MAYOR & COUNCIL COMMUNICATION

AGENDA ITEM: Halcyon Cemetery Preliminary and Final Plat

PLANNING COMMISSION
DATE: 7/13/2015
AGENDA ITEM: 4A – PUBLIC HEARING
CASE # 2015-06

UTILITY PLAN

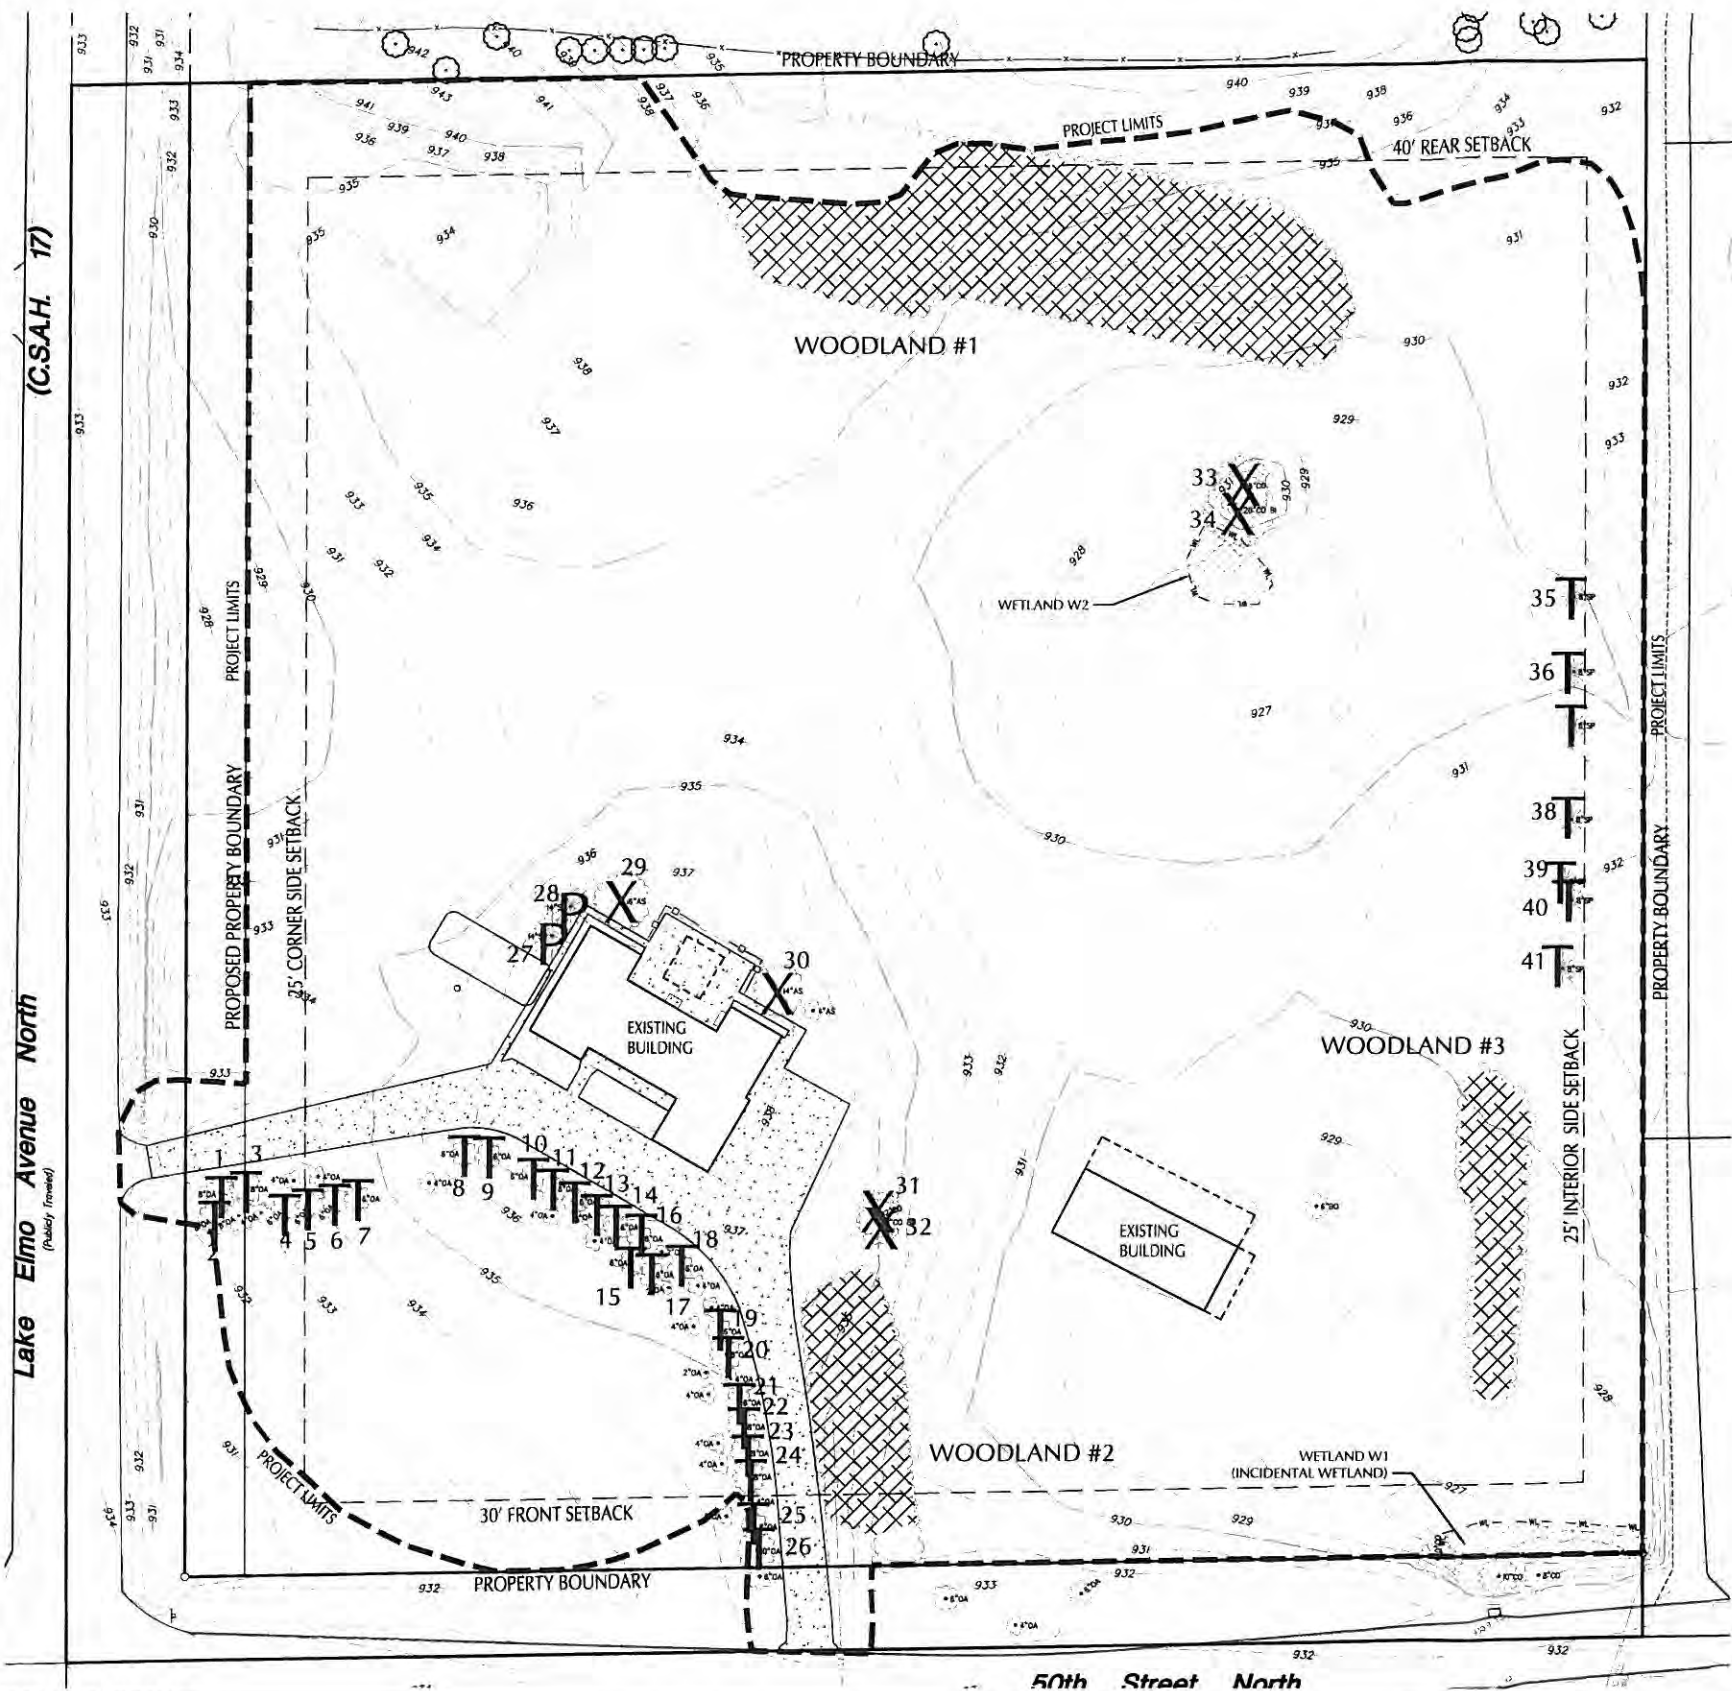
- Provide plan notes on Sheet C3-1, C3-2 and C4-1 calling out measures to protect both the existing and proposed drainfield sites throughout the construction process.

- Sheet C4-1, Utility Plan: Add note that all storm sewer pipe and storm water facilities are to be privately owned and maintained.
- Sheet C4-1, Utility Plan: Update all Plan Notes to be pertinent and consistent with the proposed Utility Plan. Generic notes appear to be inconsistent or irrelevant to this project.

TREE PRESERVATION PLAN

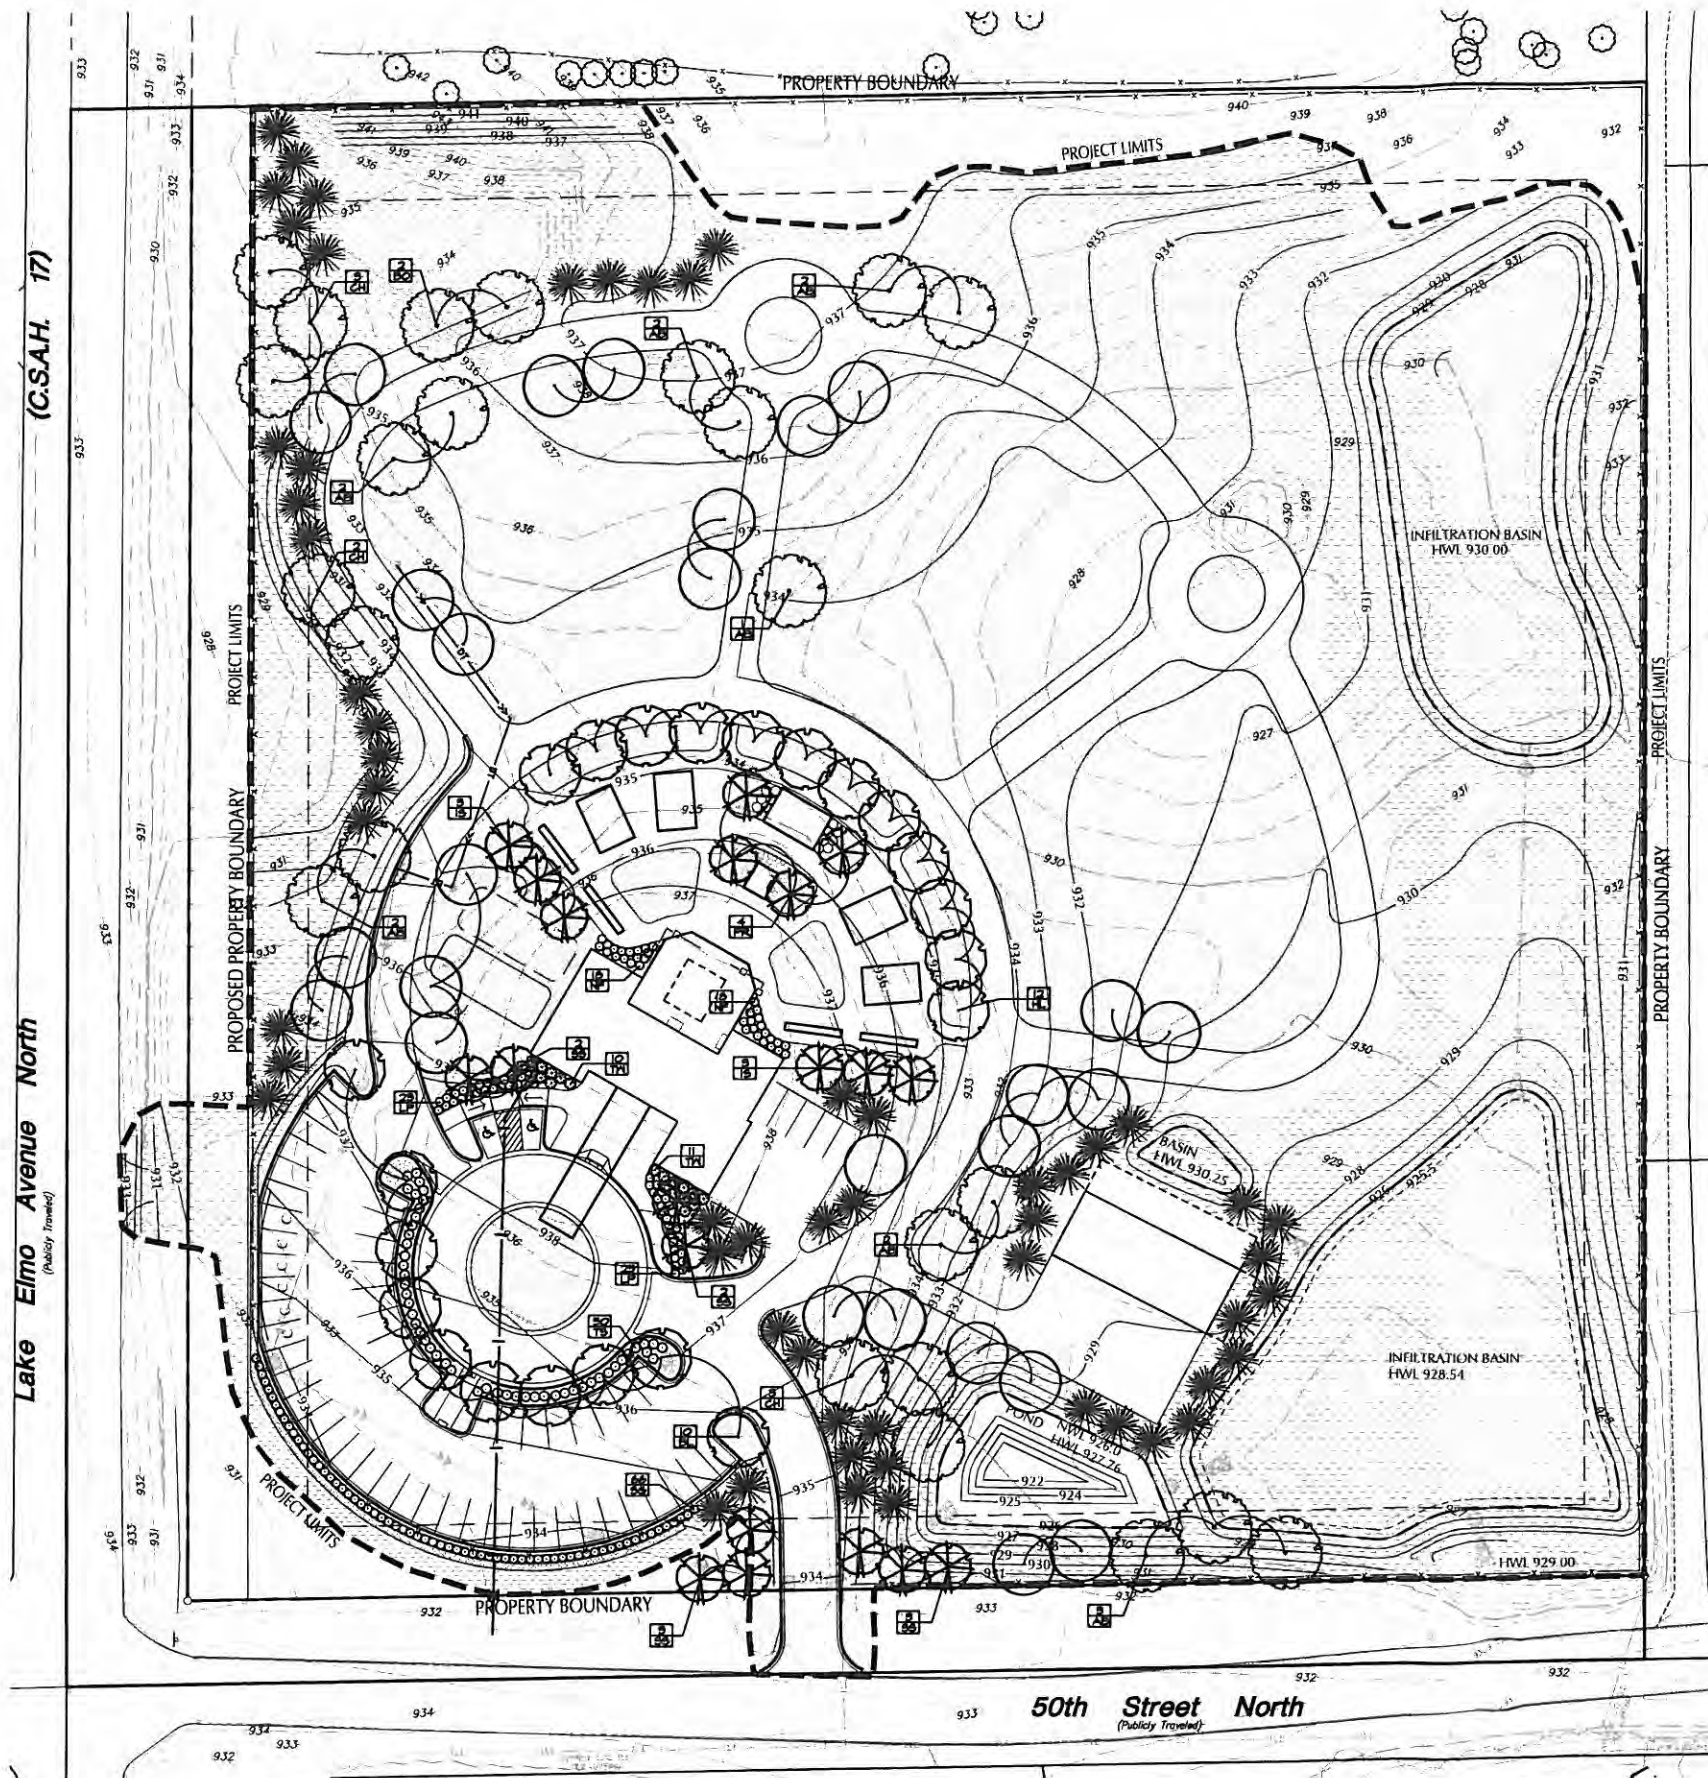
- **Tree Preservation Plan.** Staff has reviewed the Tree Preservation Plan and found it to be in conformance with the City's regulations pertaining to tree preservation for sites undergoing development activity. The total number of caliper inches on the site according to the survey is 1,550 caliper inches of significant trees. According to the Tree Preservation Ordinance, an applicant is allowed to remove 30% of significant trees on the site before tree replacement schedule is initiated. 30% of 1,550 total caliper inches is 465 caliper inches. The applicant is proposing to remove 340 caliper inches of significant trees, which is below the threshold for tree replacement. It should be noted that the applicant is proposing to transplant a significant amount of existing trees on the site to install mature plantings from an early point. Under the Tree Preservation Ordinance, transplanted trees do not count towards the total tree removals.

- The Tree Protection detail on Sheet C1-1 and Sheet L1-0 must be replaced with the City standard detail 904.

LANDSCAPE PLAN

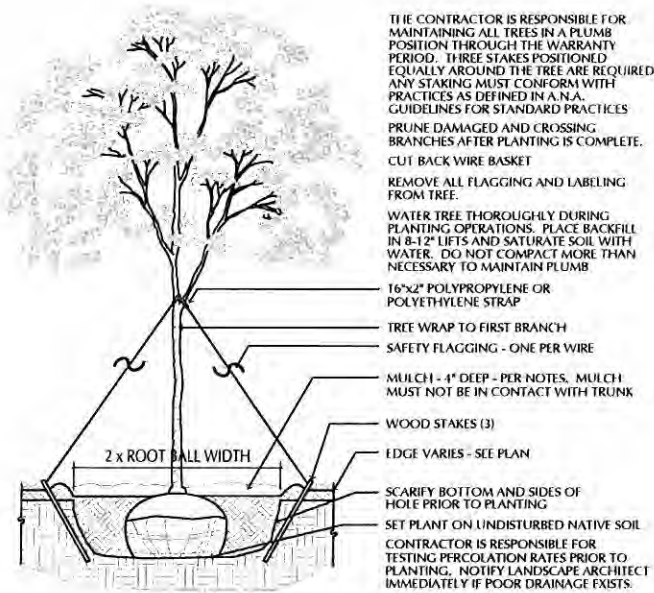
- **Landscaping.** Staff has reviewed the landscape plan submitted by the applicant and found the plan to be in general conformance with the City's ordinance. However, the applicant must provide 6 additional new trees to meet the City's quantity standards. Aside from this issue, the plant material provided meets the City standards for variety and plant size. It should also be noted that the applicant is proposing to transplant many of the existing trees on the site. In combination with the new plant material, there should be a fairly significant amount of landscaping on the 10-acre site. Staff was unable to have the plan reviewed by a registered Landscape Architect prior to consideration by the City. Therefore, Staff would recommend that the plan be reviewed for final approval prior to the installation of the plant material on the site. Finally, it should be noted that the City Engineer has identified some areas where plant material or trees are located on top of proposed utilities. The Landscape Plan should be revised to provide separation between the proposed utilities and plant material. These recommendations are included in a recommended condition of approval (Condition #5).

- 5) The Landscape Plan shall be revised to include 6 additional trees to fulfill the City's Landscaping Requirements. In addition, the plant material that is on top of utilities shall be moved to comply with the direction of the City Engineer per his memorandum dated July 8, 2015. Finally, prior to installation of plant material, the plan shall be reviewed by the City's Landscape Consultant for final approval.
